# Rezoning Transportation Analysis

Petition Number: 2019-043

General Location Identifier: 05327108, 05327126

Date	Description
04-21-2019	First Review

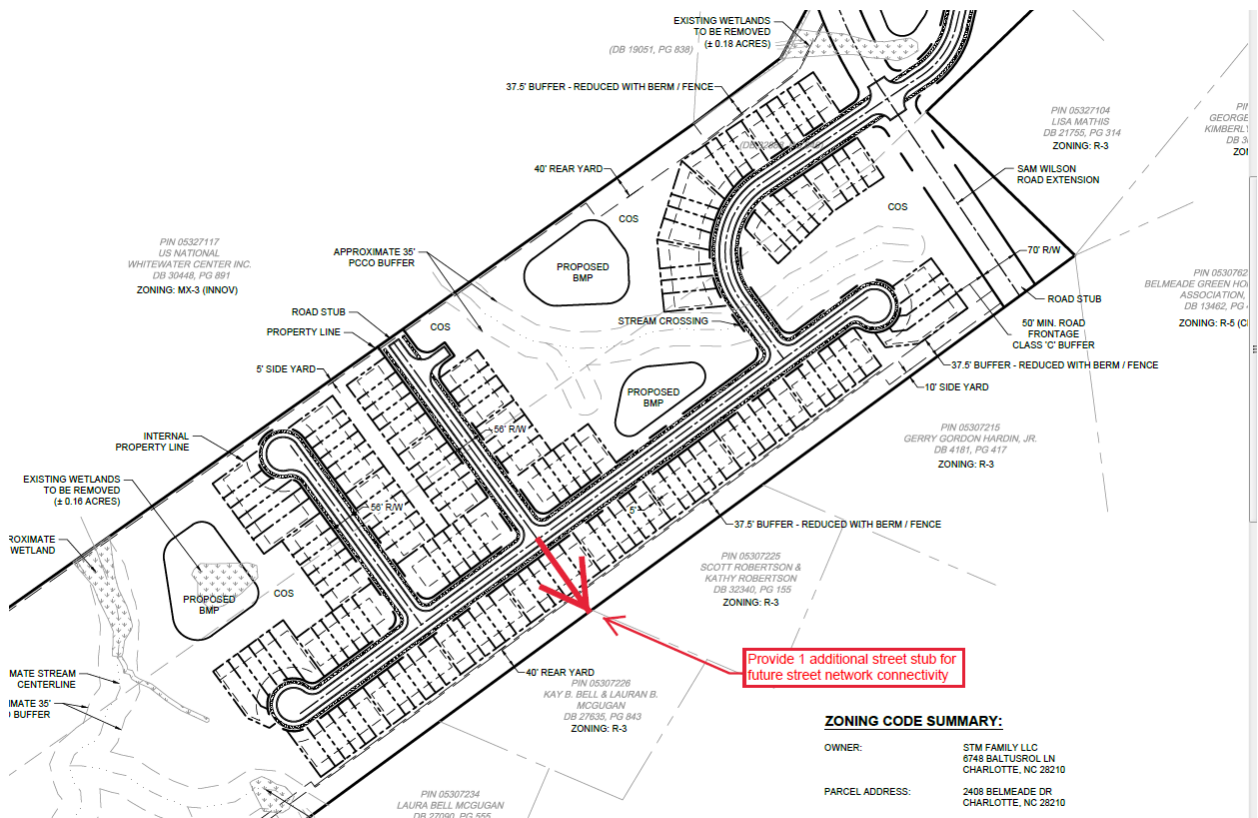
4. The petitioner should revise the site plan and conditional note(s) to specifically state the construction of an 8' planting strip, and 6' sidewalk along the site's Belmeade Dr. frontage, per the City's current subdivision ordinance.
5. The petitioner should revise the site plan and conditional note(s) to provide a 150' westbound Belmeade Dr. left turn storage lane with an appropriate bay taper at the proposed subdivision's main entrance street.
6. The petitioner should revise the site plan and conditional note(s) to specifically state and depict one (1) additional street stub to the southeast (see below concept).
